Planning Commission Vote Report

Subject: Zoning Map Amendment

Petition: **P.Z. 07-2015 Monsanto Chesterfield Campus (C8 to UC)**

DRAWING TITLE
SIGHT LINE SECTION

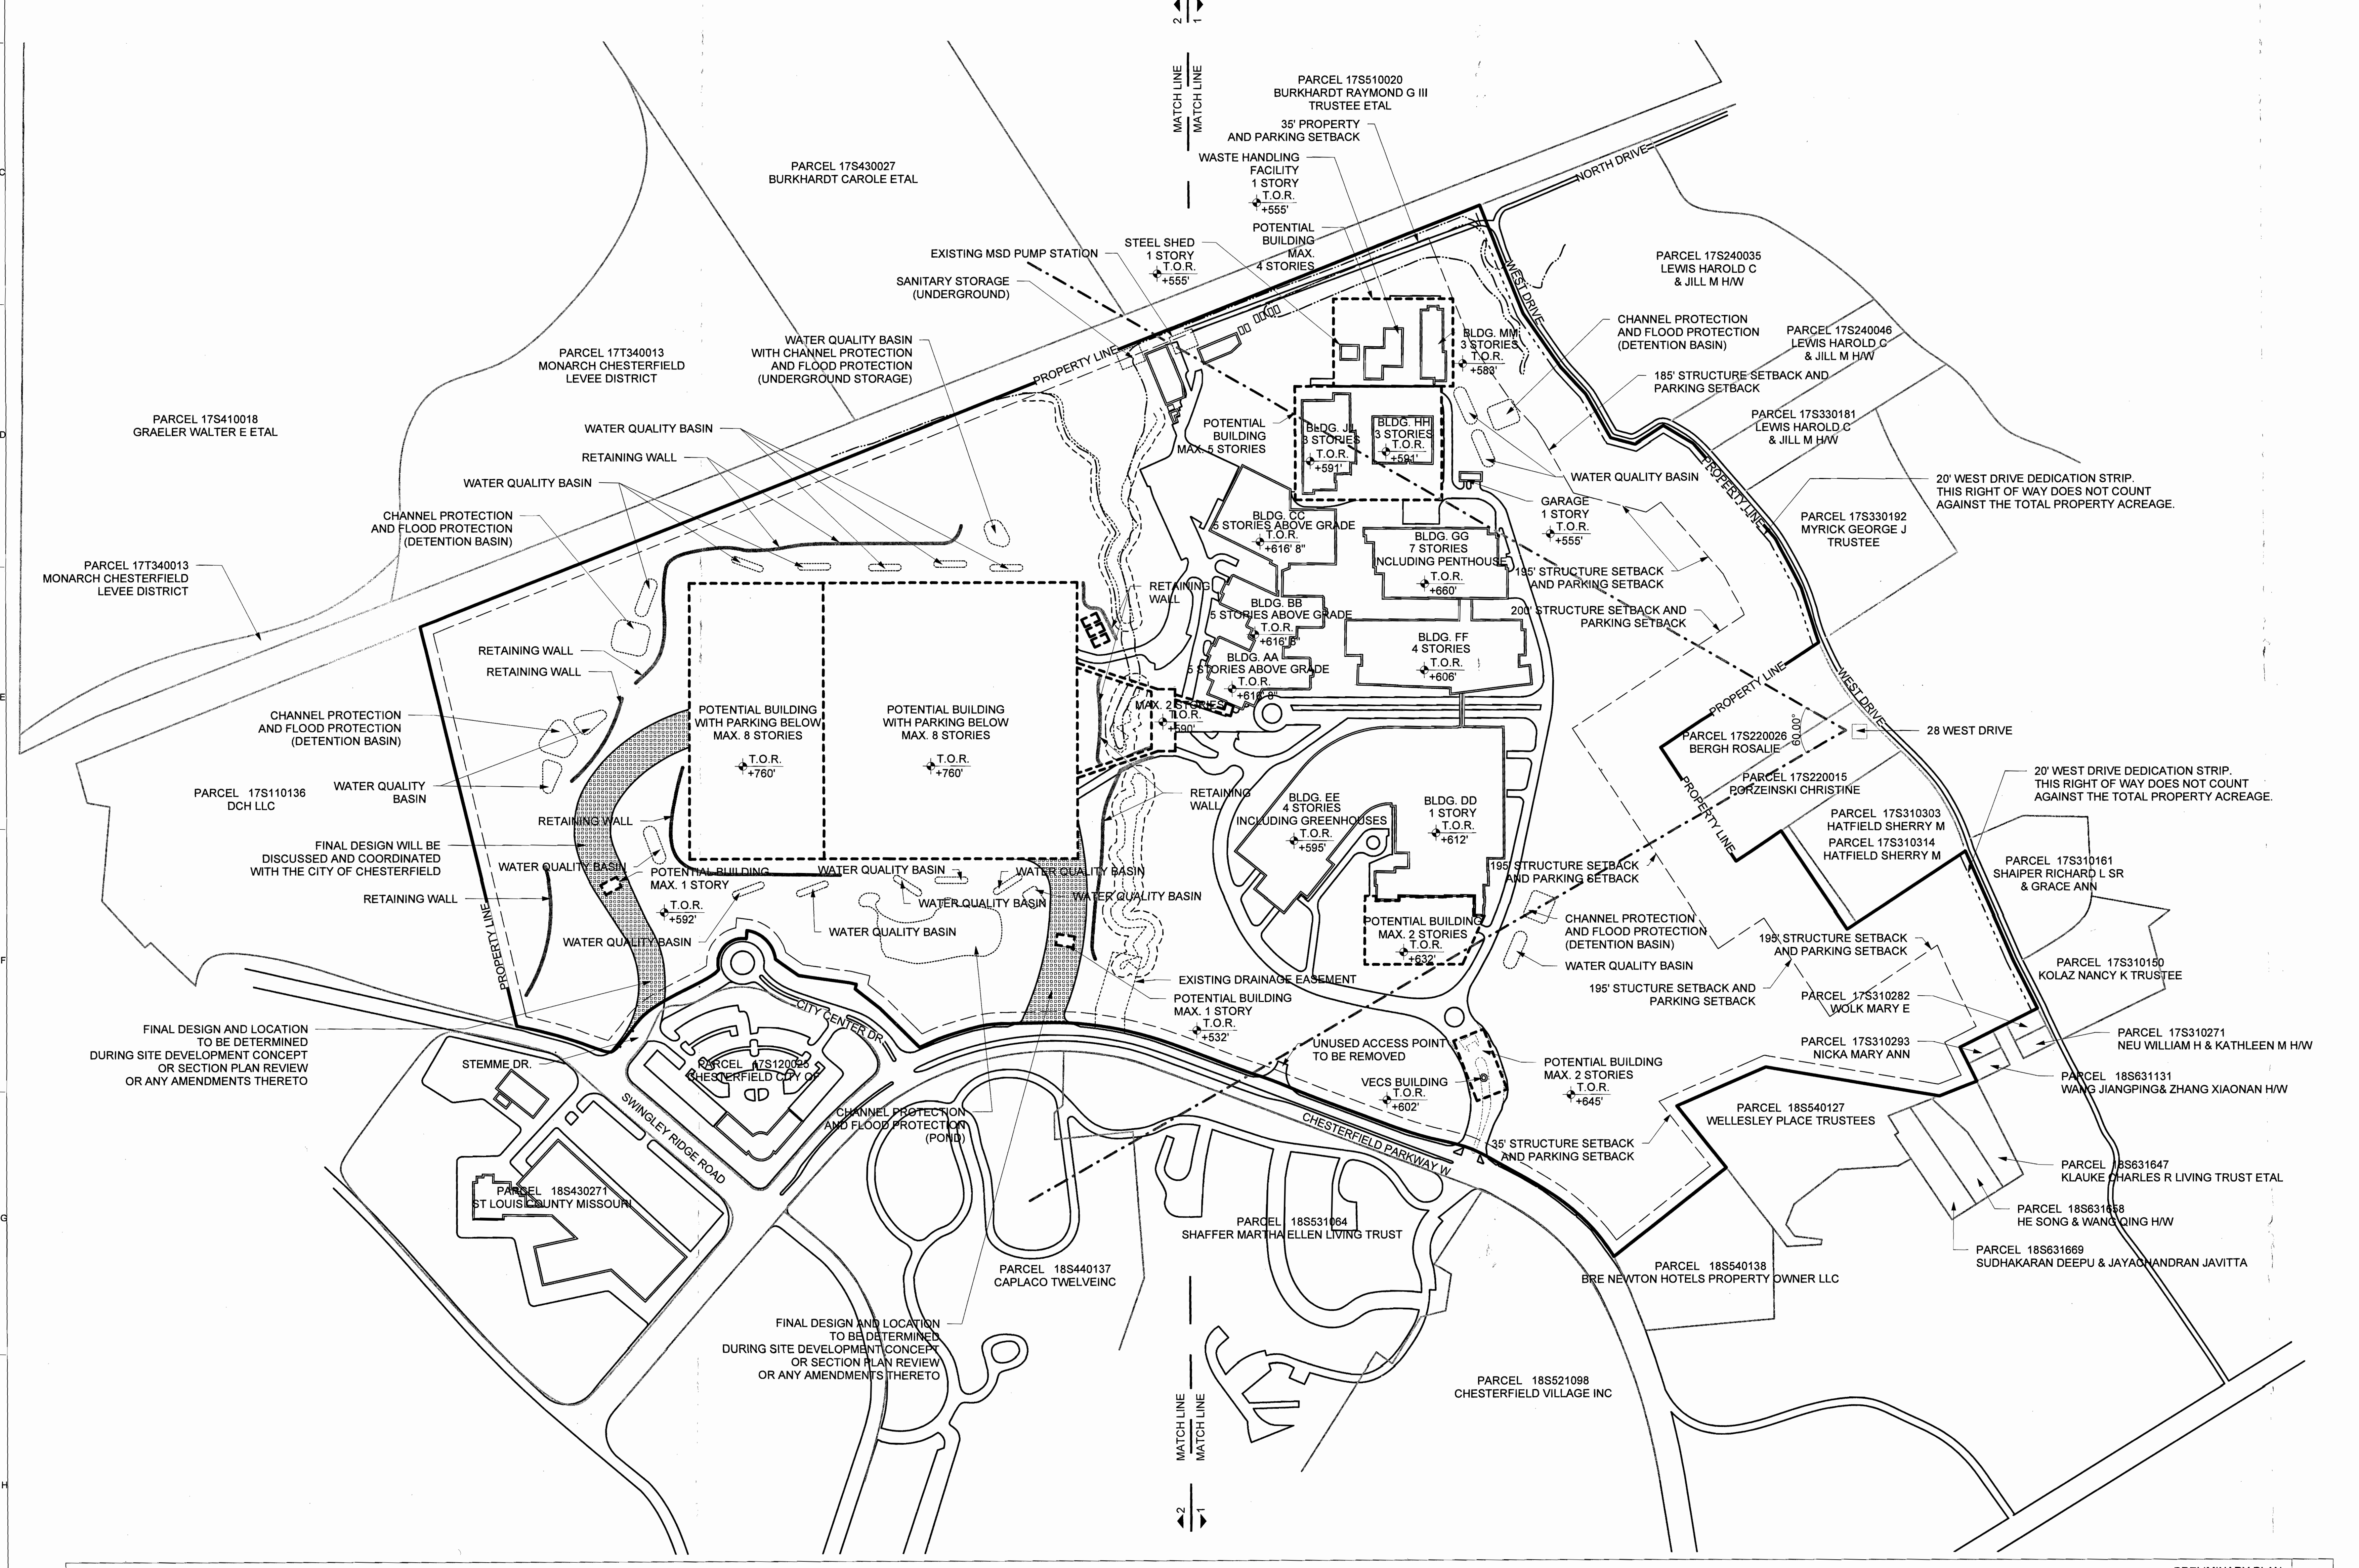
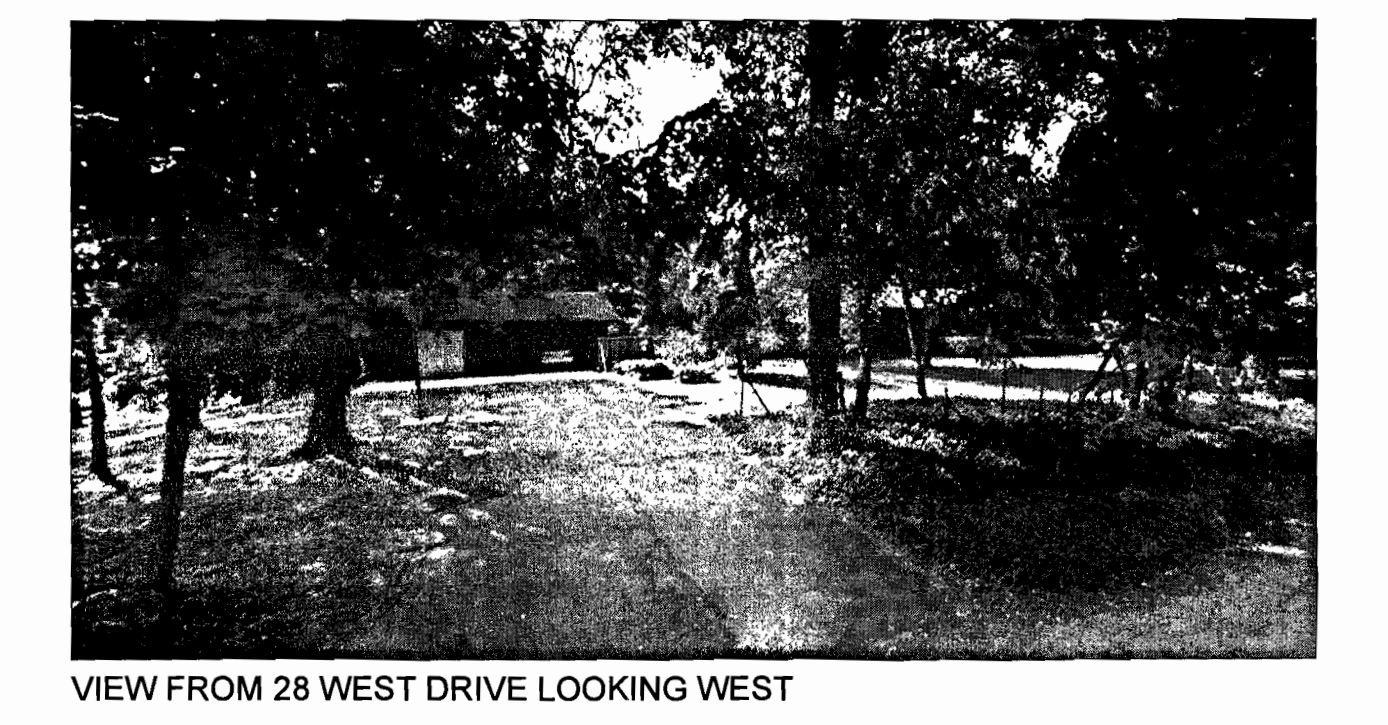
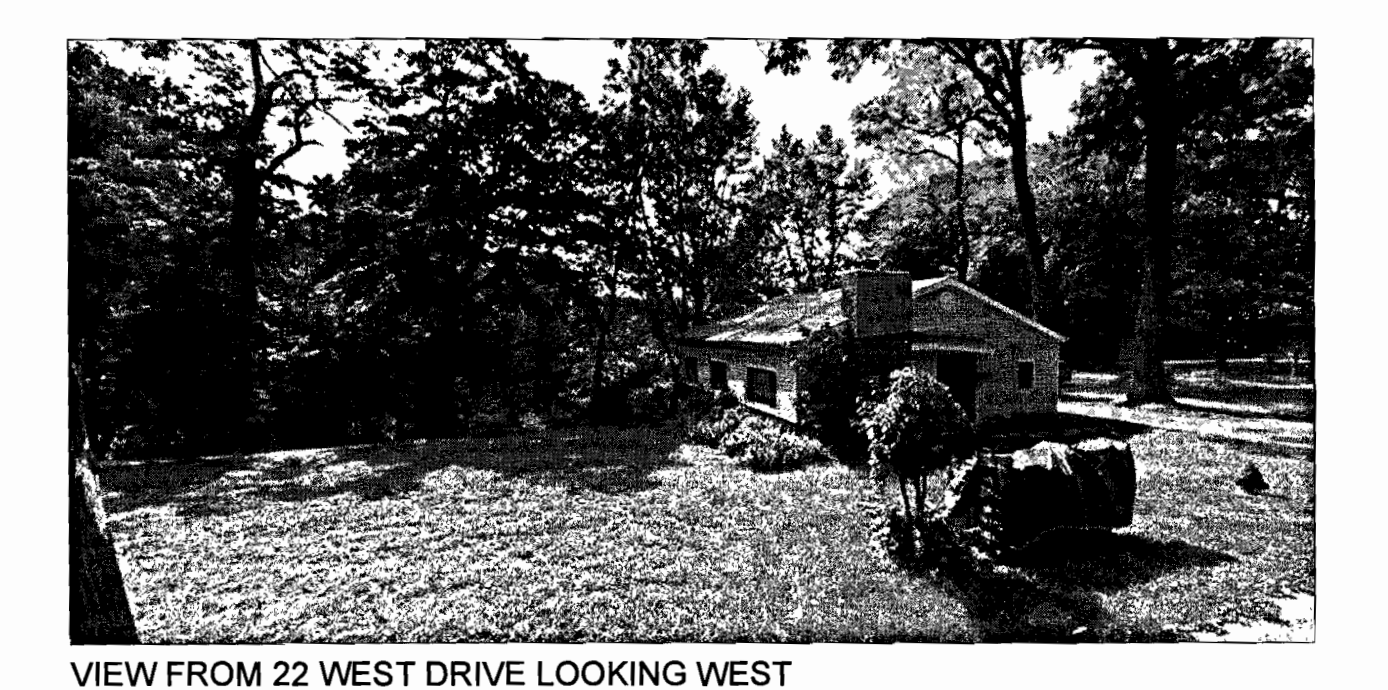
1. Height of proposed structures relative to residences off West Drive. As indicated in the Comprehensive Plan Analysis above on page 4 of this report, the applicant is proposing to build multiple structures with the tallest being eight (8) stories in height and 750 Mean Sea Level (MSL) on the western side of the campus. While the eight stories limitation would be compliant with UC District minimum requirements, area residents voiced concern with tall structures near West Drive. The applicant has indicated via the proposed preliminary plans that no new structures are proposed near these residents off West Drive.

Additionally, a sight line study has been submitted for City evaluation and is included with the Preliminary Plan. The area between the proposed and existing buildings and the adjacent West Drive residences is heavily wooded and not only features a large ravine, it also contains a natural watercourse, which contributes to the Petitioner's intent to avoid future development in this area as shown on the Preliminary Plan. Based on this information, it is Staff's opinion that the significant distance, topography, existing forestation, and large setbacks (see below) will sufficiently mitigate the impacts to the adjacent residents on West Drive.

Further, the preliminary plan identifies structures on the eastern portion of the site as limited to between three (3) and five (5) stories in height. The tallest, eight (8) story building will be located west of the existing buildings and will not impact views from West Drive.
